GeoShield Verification Report 22

PROJECT REFERENCE: GEO103260 R22

PROJECT: Riverside Academy

Installation of Juta GP1 Gas Barrier

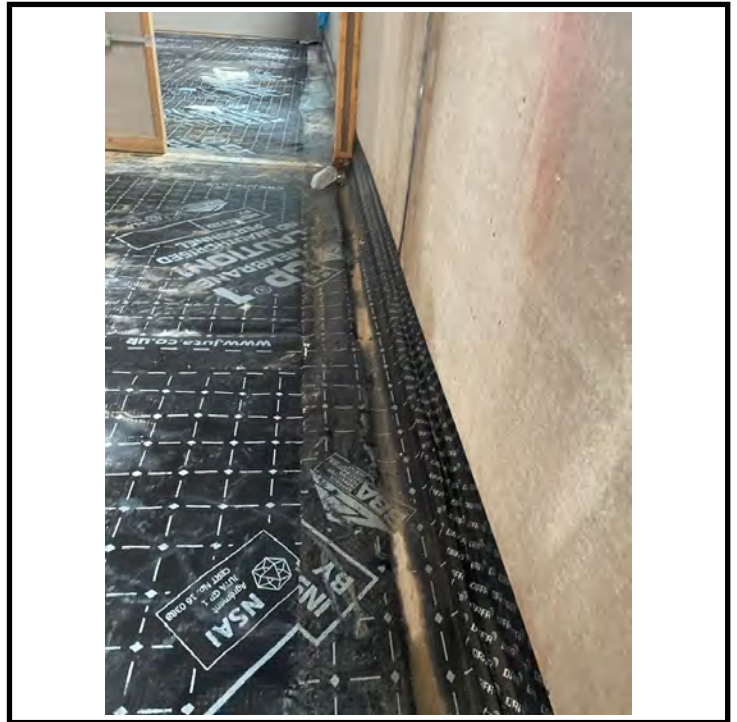
The above photograph displays a mechanical point stress test, also known as a pick and probe test, being conducted upon a welded lap joint of the Juta GP1 Gas Barrier. All lap joints throughout the installation were subjected to thorough pick and probe testing. Several miswelds were identified, all of which were remediated on site in the presence of GeoShield.

Faults Identified and Remediated

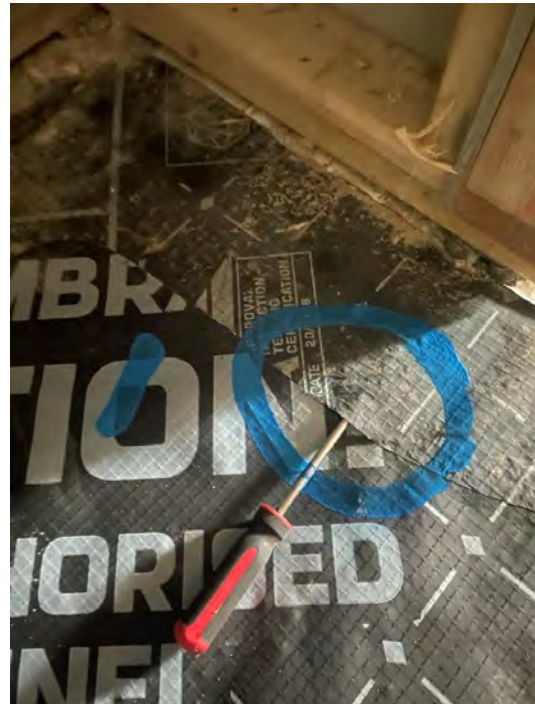
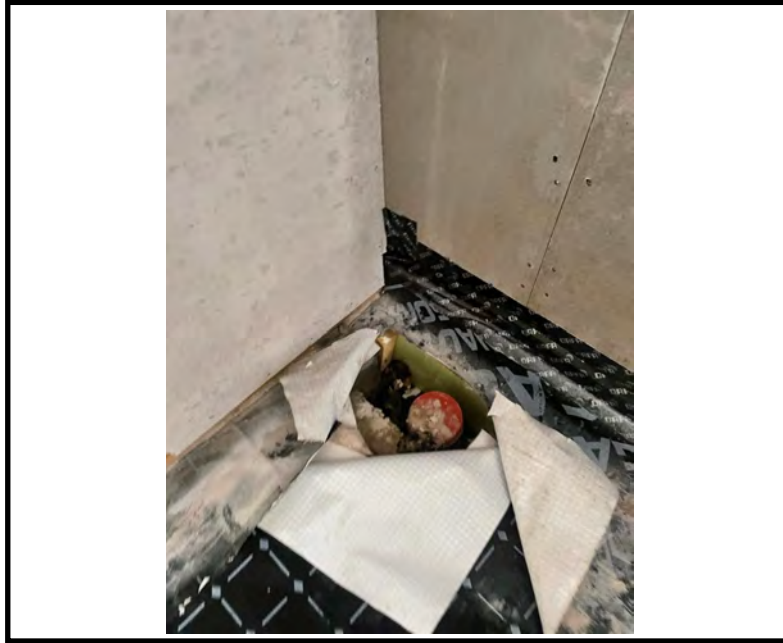
As mentioned in this report, the thorough mechanical point stress testing which supported the initial visual inspections conducted across the Juta GP1 infill installations identified several faults. These were primarily small holes or miswelded lap joints around the perimeters of the rooms. All faults were highlighted for ease

of identification and remediated on site in the presence of GeoShield. The specialist installers from SWC opted to apply 150mm patches of Juta GP SAM upon the affected areas, as shown in the photographs above. This has reinstated the continuous seal across the affected rooms.

All patch repairs were subjected to thorough mechanical point stress testing. No further faults or defects were identified with the remediations during these testing procedures. Tested and verified in accordance with CIRIA 735.

West Wing - External Perimeters

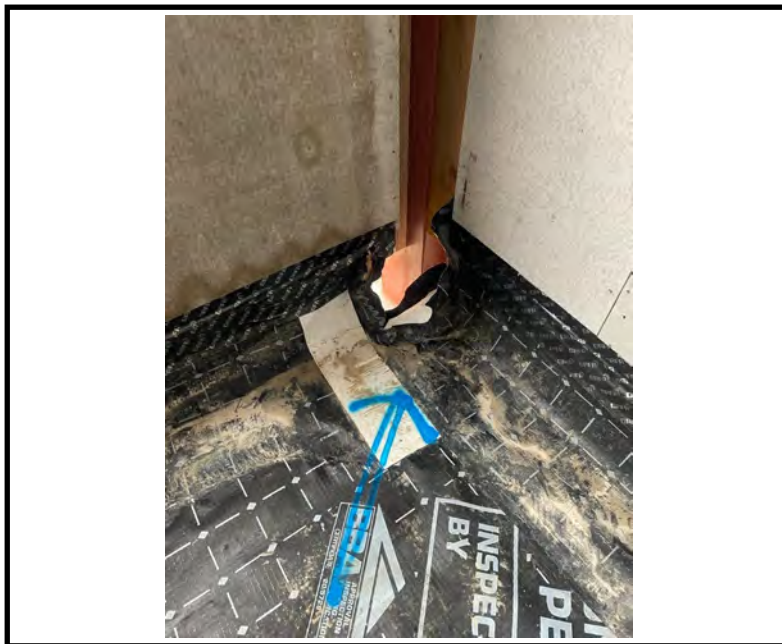
There is two steel stanchions within the west block that required sealing on the external side of the perimeters. These were in the corners of the blocks. These areas will be boxed out prior to being screeded and sealed additionally and verified on the next visit.

There is also a pipe service penetration which requires extending, as shown in the photograph above. Again, this will be verified and passed off at the next visit but in the meantime this will be boxed out prior to screeding commencing.
